# 42 Honeysuckle Drive

State Significant Development (SSD-10378)

DEVELOPMENT MODIFICATIONS

March 2022

# 3.1 Design Changes West Elevation

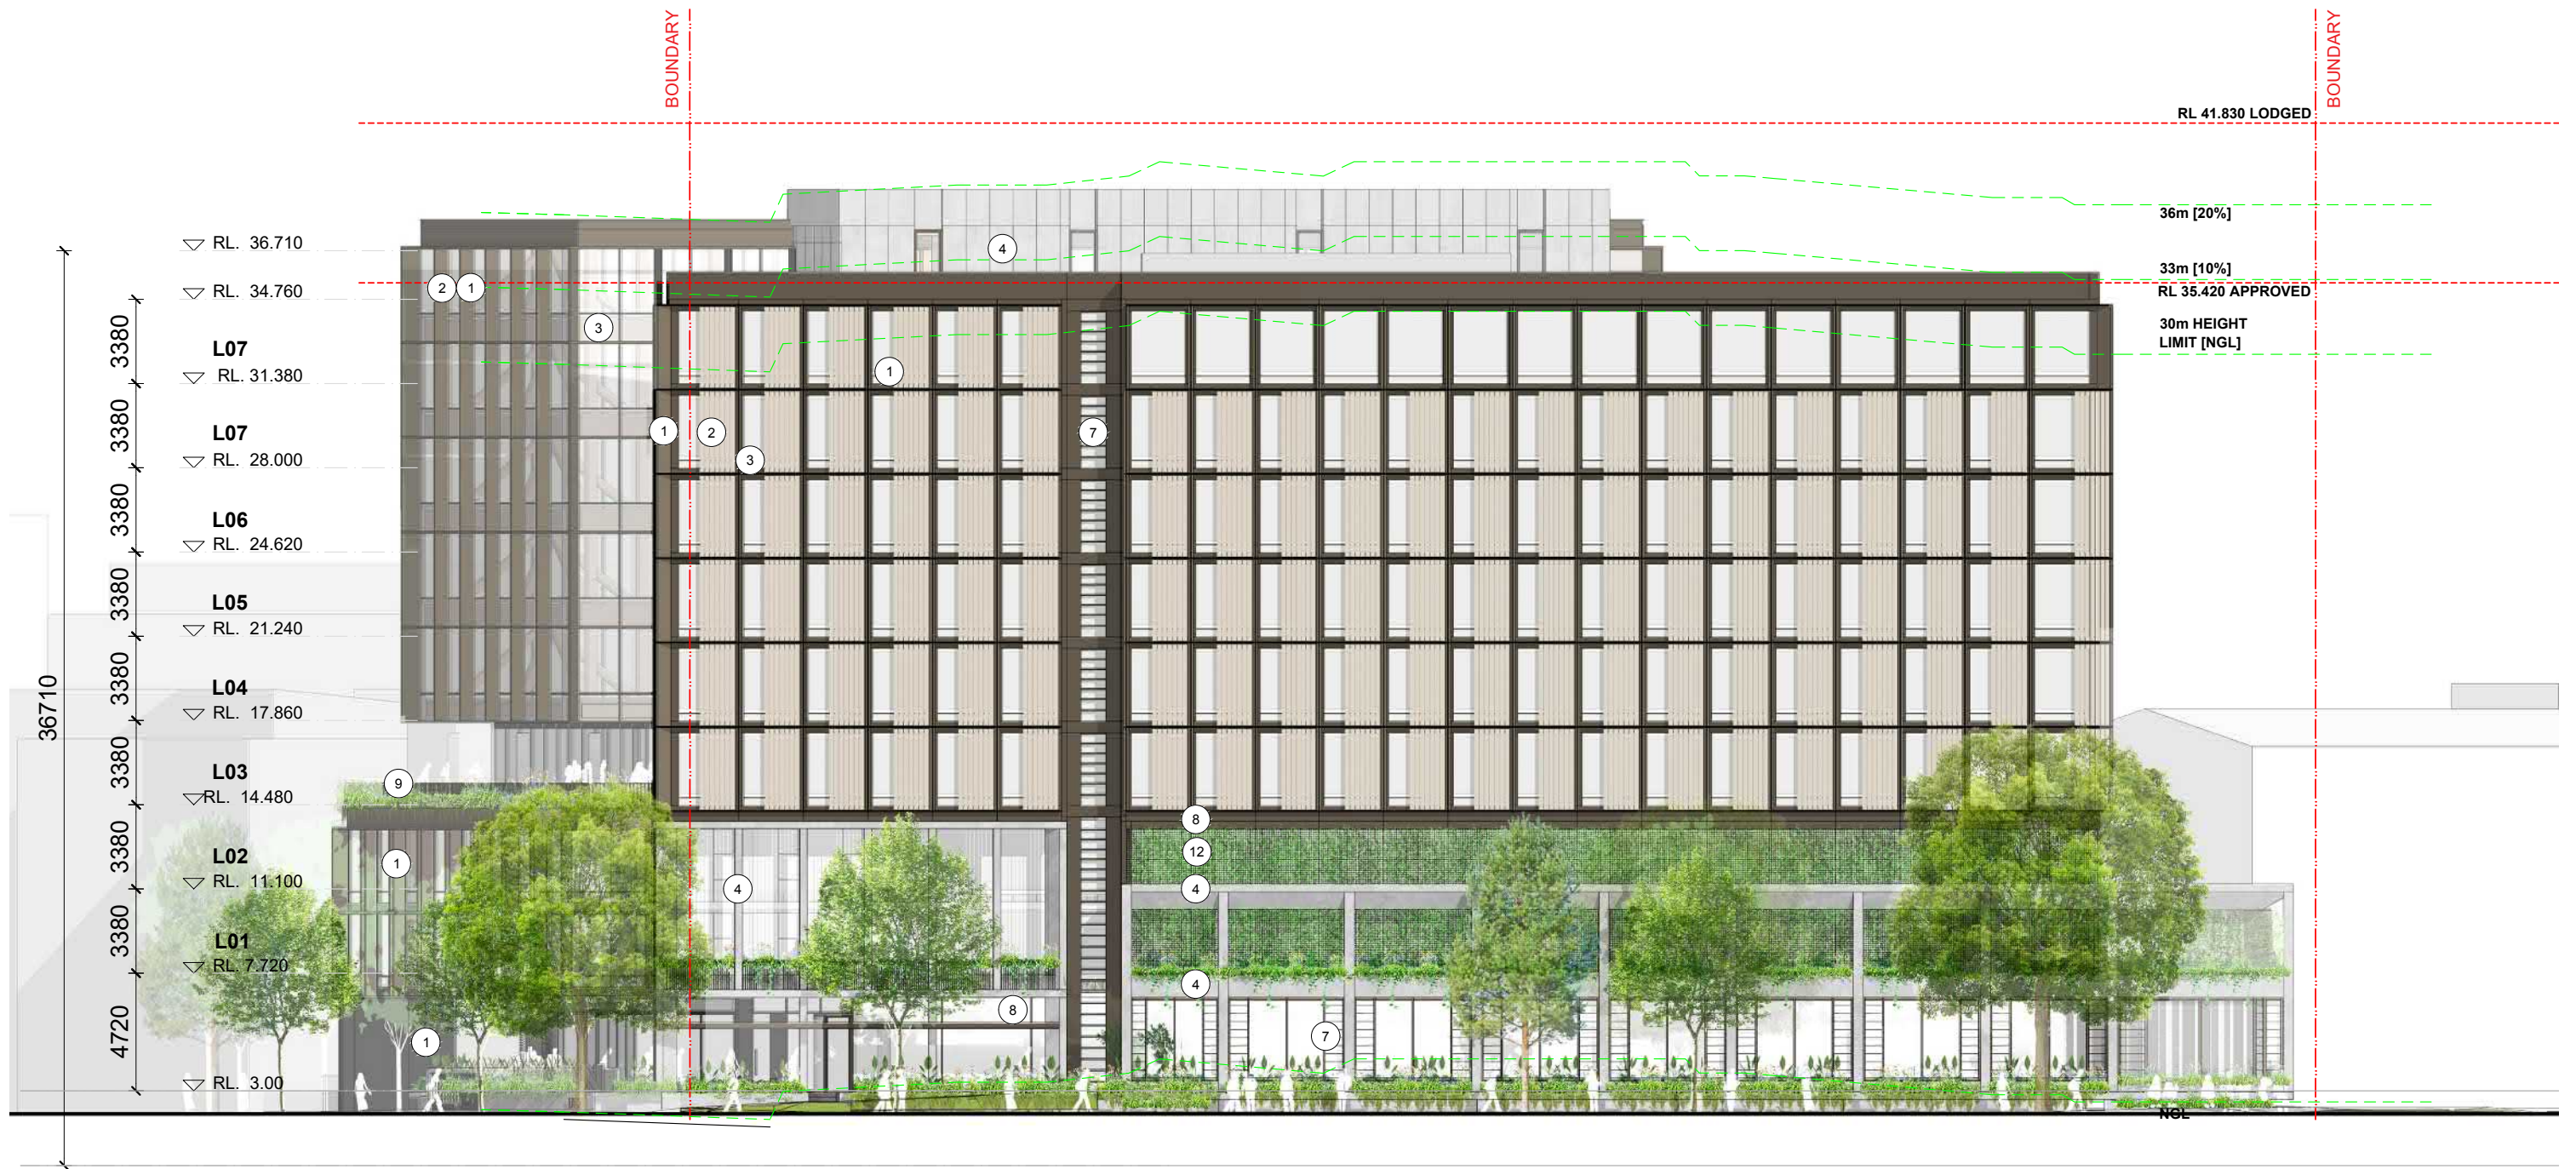
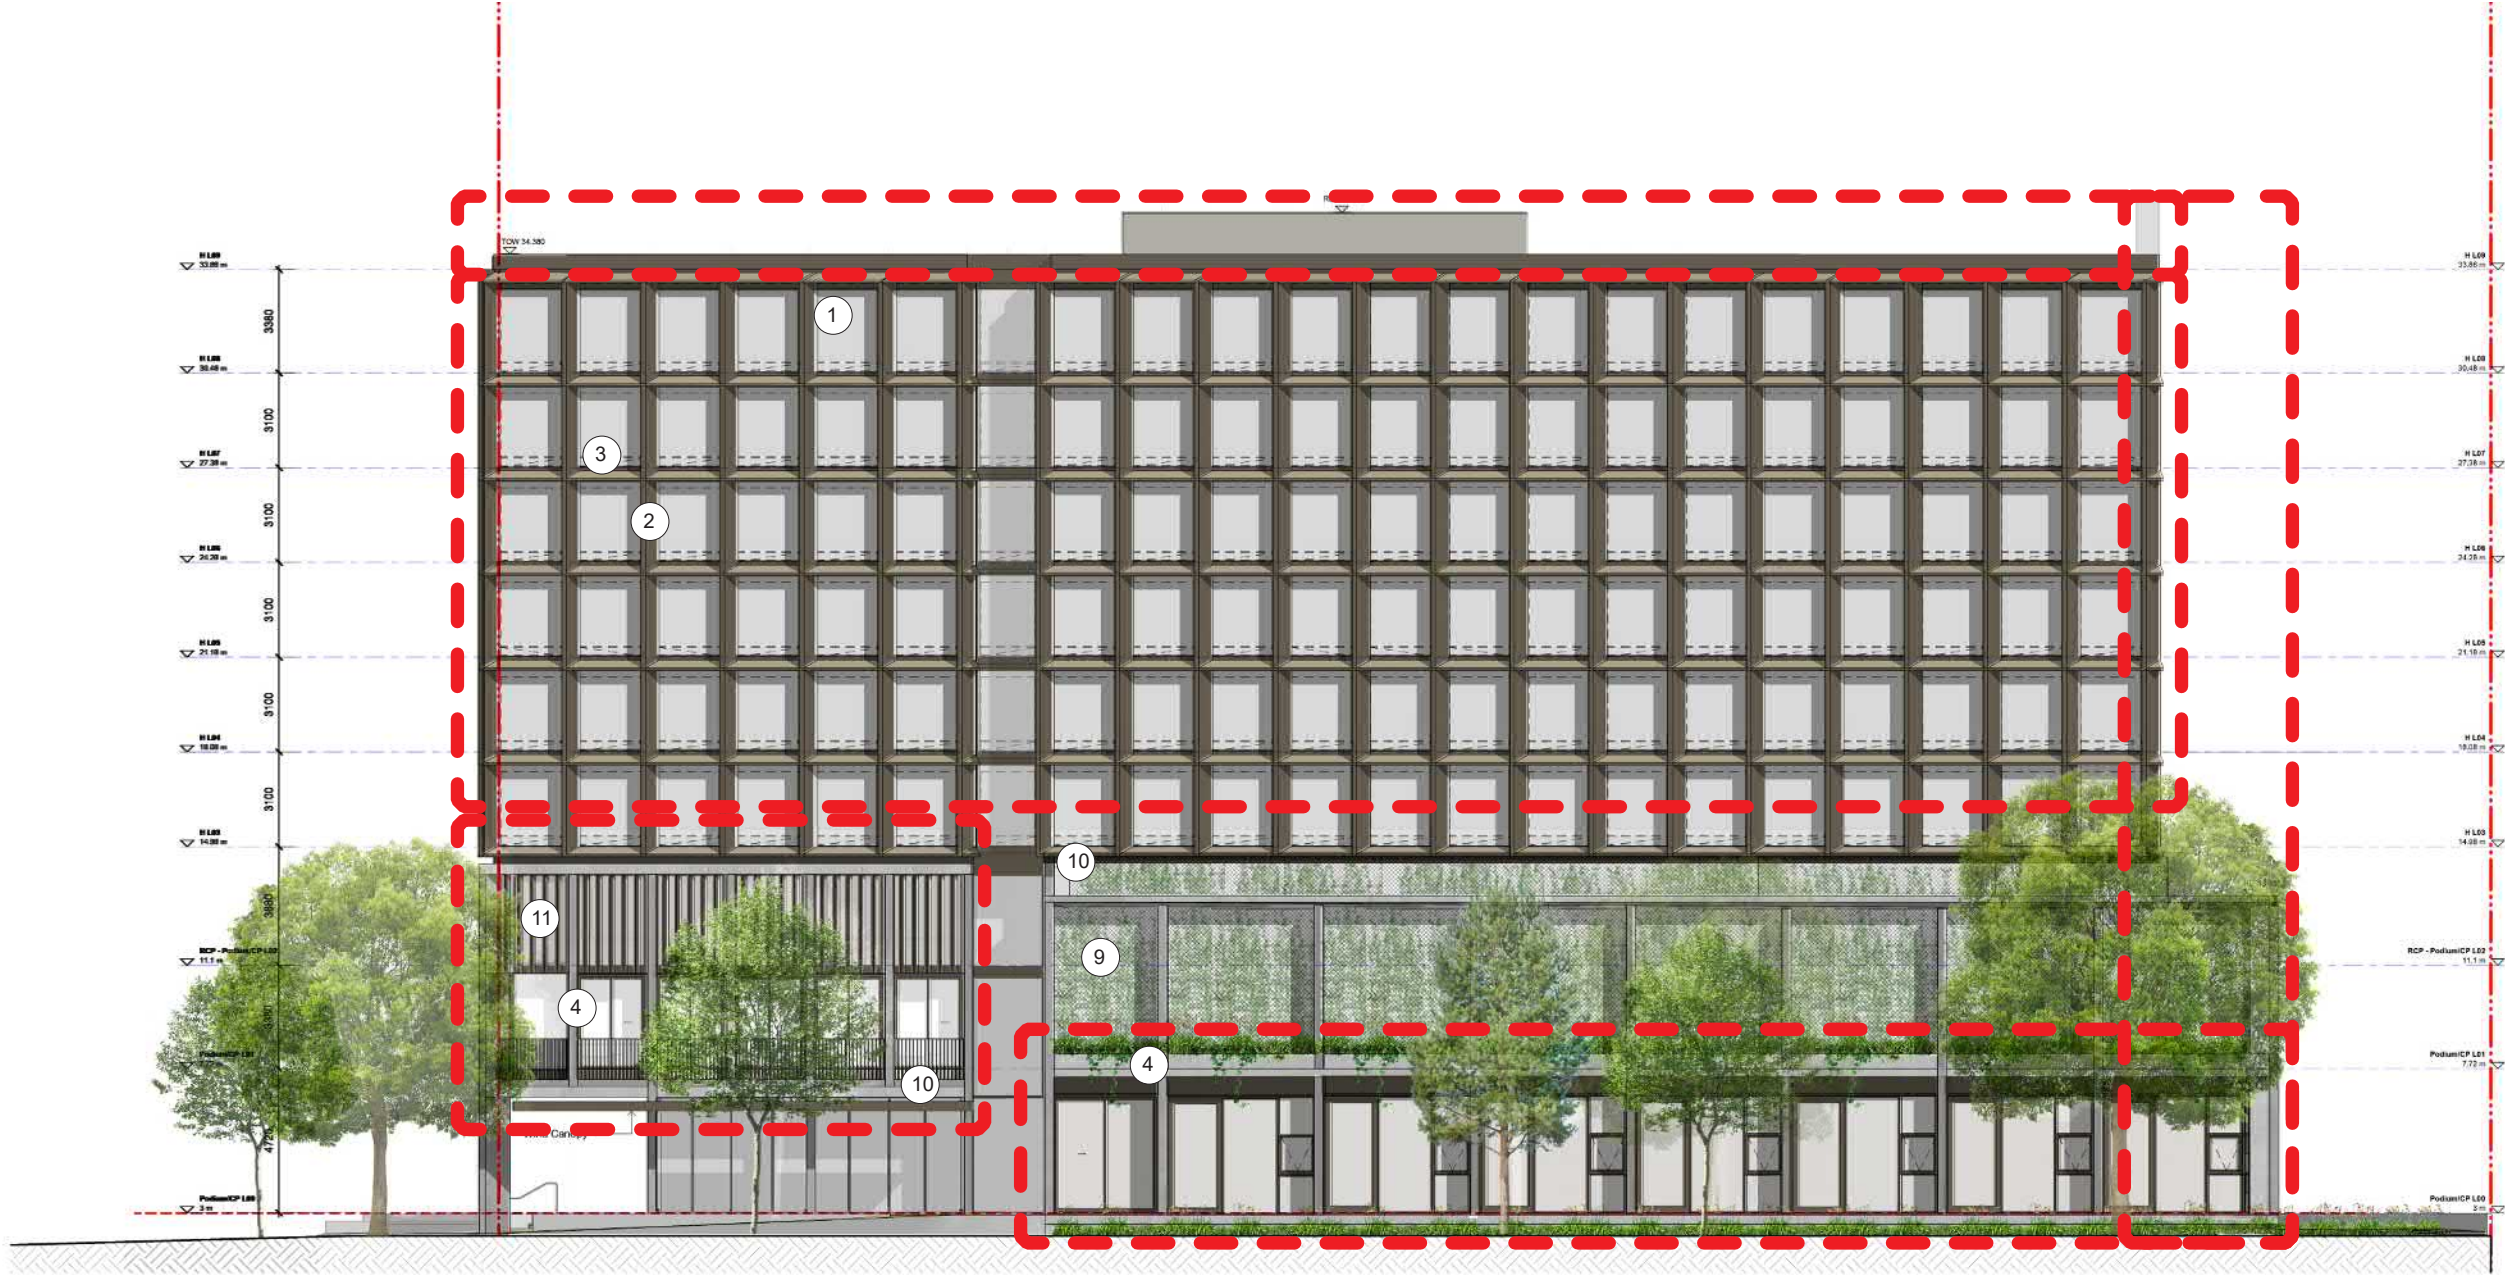
- 1 / Hotel slab to slab levels reduced from 3380mm down to 3100mm. This has resulted in an overall hotel building height reduction.
- 2 / L01 and L02 North/west corner amended. External terrace omitted and sun-shading added to level L02
- 3 / Hotel south end of building has been reduce in length by 1 hotel room width.
- 4 / Arbor structure has been pulled back at the south boundary.

- 5/ Ground floor facade to meeting rooms and gym has been amended. Glass louvres removed and sliding doors and operable windows added.
- 6/ Hotel facade from levels L03 to L08 - external louvres have been omitted and an angled 600mm deep vertical and horizontal sunshade added
- 7/ Facade colours and materiality remain the same
